*** FINAL DRAFT ***

July 15, 2021
GZA File No. 175211.00

RE: Engineering Peer Review
Proposed Residential Development
300 Stone Street (Lot 2)
Walpole, MA

Figure 2: FEMA Flood Insurance Rate Map (2012)

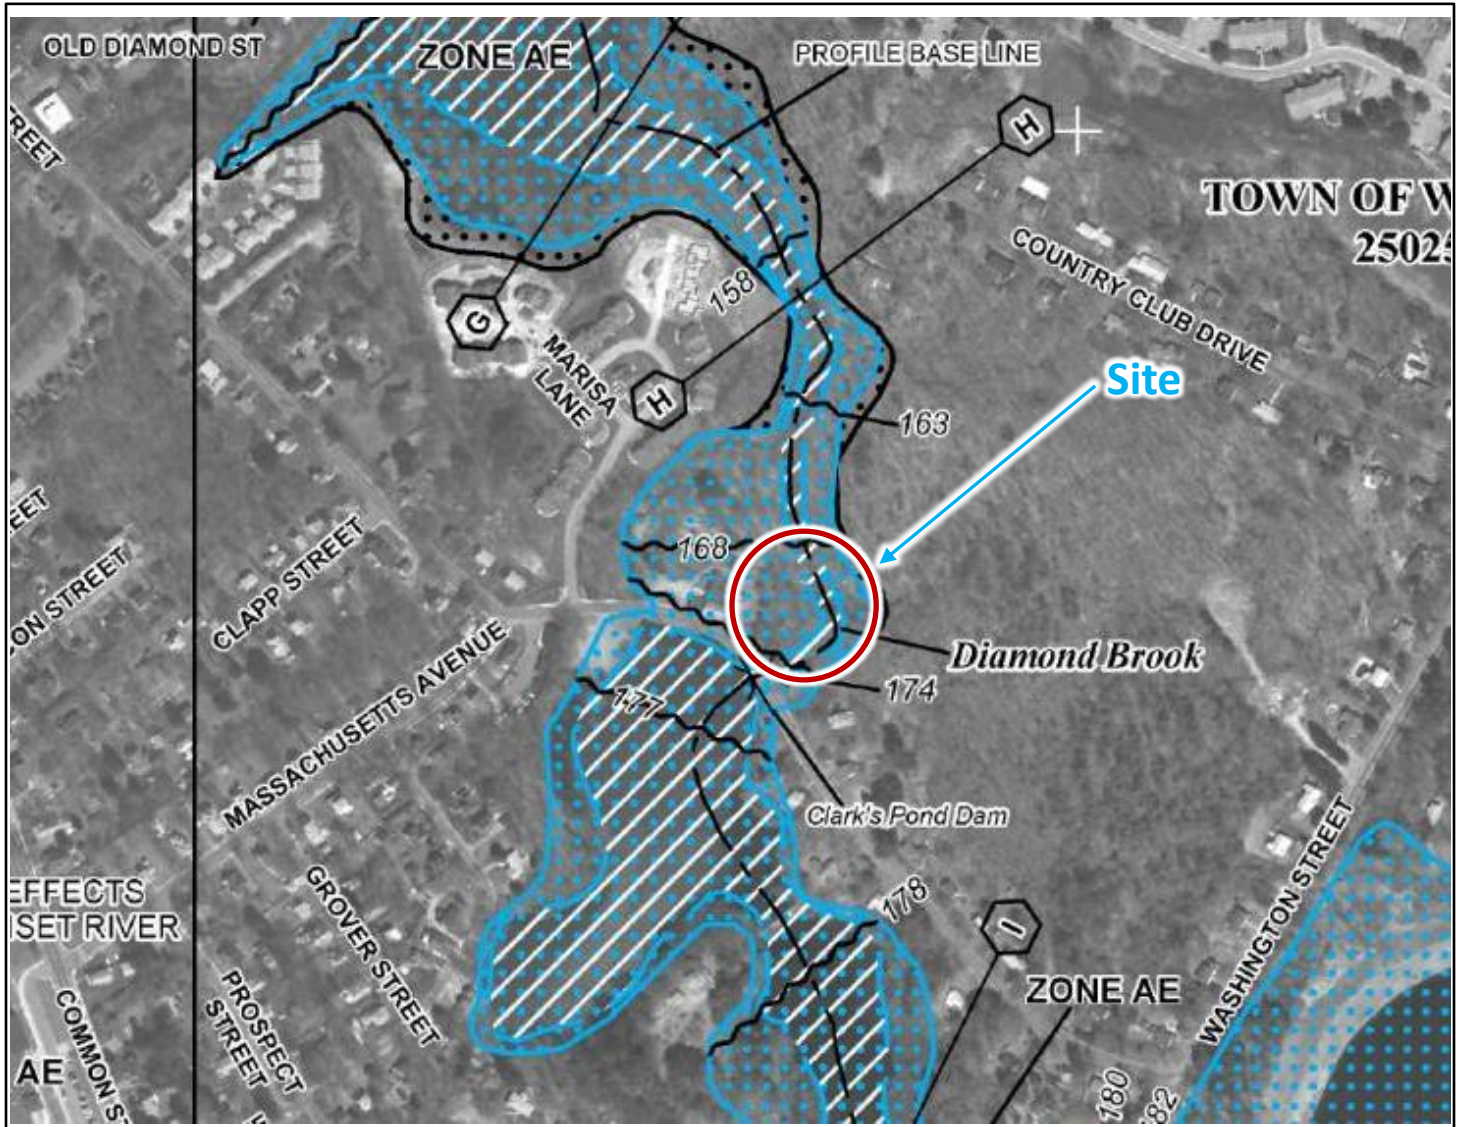
The Site is situated within Walpole's Flood Plain Protection Overlay District and is fully encompassed within the 100-year floodplain as published in the latest Flood Insurance Rate Map (FIRM) by FEMA (effective date July 17, 2012). Relevant portions of the FIRM are presented in **Figure 2**. Base flood water surface elevation across the site ranges from approximately 170.0 to 174.0 (NAVD88), based on the published FIRM. The 100-year flood level in Clarks Pond, in the vicinity of the Stone Street dam outlet is at Elevation 177.0. Based on the average roadway grade elevation of 176.5 (taken from the GLM site base map), the dam/roadway would be likely overtopped and susceptible to an erosion failure during the 100-year flood. Shallow flooding depths of about 0.5 foot would be expected across the majority of the Site, under the 100-year event (not including dam failure). However, flood depths in the brook would be more in the range of 2 to 3 feet, with related higher flow velocities.

Figure 3: Proposed Development at 300 Stone St Lot 2, Walpole, MA

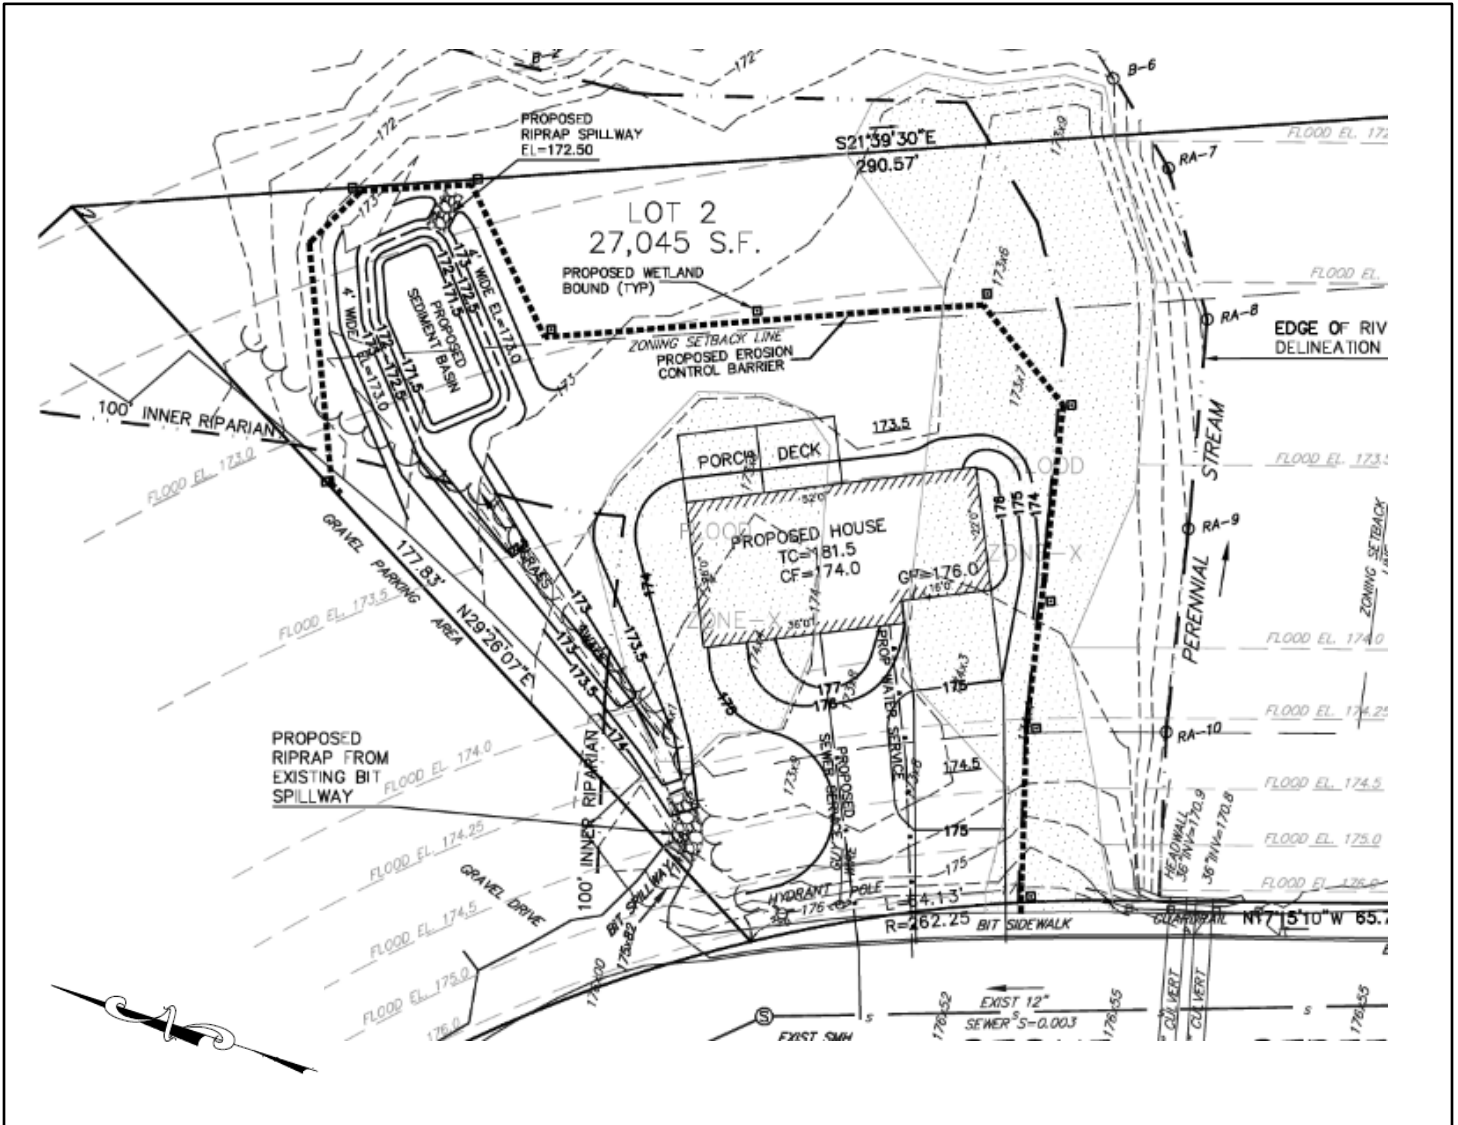
GZA's understanding of the applicant's proposed dwelling configuration and floodplain mitigation measures were primarily derived from review of the GLM engineering drawings (see **Figure 3**). The dwelling is to have a 1,460 ft² footprint with slab-on-grade foundation. The top of foundation slab is to be set at elevation 174.0 with a finished ground floor elevation of 176.0, which is above the published FEMA 100-year flood elevation. However, other portions of the property surrounding the dwelling structure will remain in the 100-year floodplain. Based on the Applicant's documentation, mitigation measures due to the proposed land disturbance will primarily include creation of new flood storage to compensate flood volume loss due to filling and re-grading of the Site. Based on the use of simple flood storage

compensation techniques, the estimated storage volume loss of 276 ft³ will be compensated with a volume of 875 ft³, a 3 to 1 ratio.

In addition, the proposed development is to include a small “sediment basin” located near the northwest corner of the property (**Figure 3**). This basin is to be about 1.5 feet high, with a riprap spillway set at a level about 0.5 feet below the top of the basin. A new grass-lined swale will allow roadway stormwater from the existing paved swale, along with some site runoff, to enter the basin. It appears that the basin will operate as a detention basin, however it is unclear how this structure’s storage volume and spillway configuration were sized (i.e. design storm) and how the basin would operate under the 100-year storm. Please note that GZA did not review regulatory requirements for the proposed detention basin per Massachusetts Clean Water Act.

1. The compensatory storage calculation fulfills the requirement in Section 11.3.B.2 of the Zoning By-Law. However, in GZA’s opinion, reliance solely upon the compensatory storage is an oversimplified mitigation technique given the Site’s extremely sensitive location immediately north of Clarks Pond, in close proximity to Spring Brook, as well as the property being fully within the 100-year floodplain. The compensatory volume technique is static and does not properly address the potential changes in actual flow dynamics at and near the brook as a result of encroachment of the Site’s flood overbank areas due to filling and other land disturbances. Potential changes in flood flow conveyance, due to the proposed filling, may alter flow velocities resulting in increases in water surface elevations. The proposed construction seems to be constricting the flow area downstream of the Stone Street culverts so that depths may increase at the Site and vicinity. This may exacerbate flooding on and off the Site as well as alter the tailwater characteristics at the downstream end of the dam’s outlet culverts at Stone Street. At a minimum, GZA recommends that the Applicant commission the performance of a detailed backwater computer simulation to estimate the 100-year water surface profile under both pre- and post-development conditions. The analysis, using HEC-RAS or other comparable hydraulic program, should be done from a point downstream of the Site and up through the Stone Street culverts up to Clarks Pond.

4. Additional hydrologic and hydraulic engineering information should be provided related to the design of the Sediment Basin. Specifically, an inflow/outflow storage routing computation should be provided that quantifies the contributory rate of runoff to the basin emanating from the roadway and from the Site. How accumulated sediment will be removed and other maintenance/performance of the basin under the 100-year flood should be included.
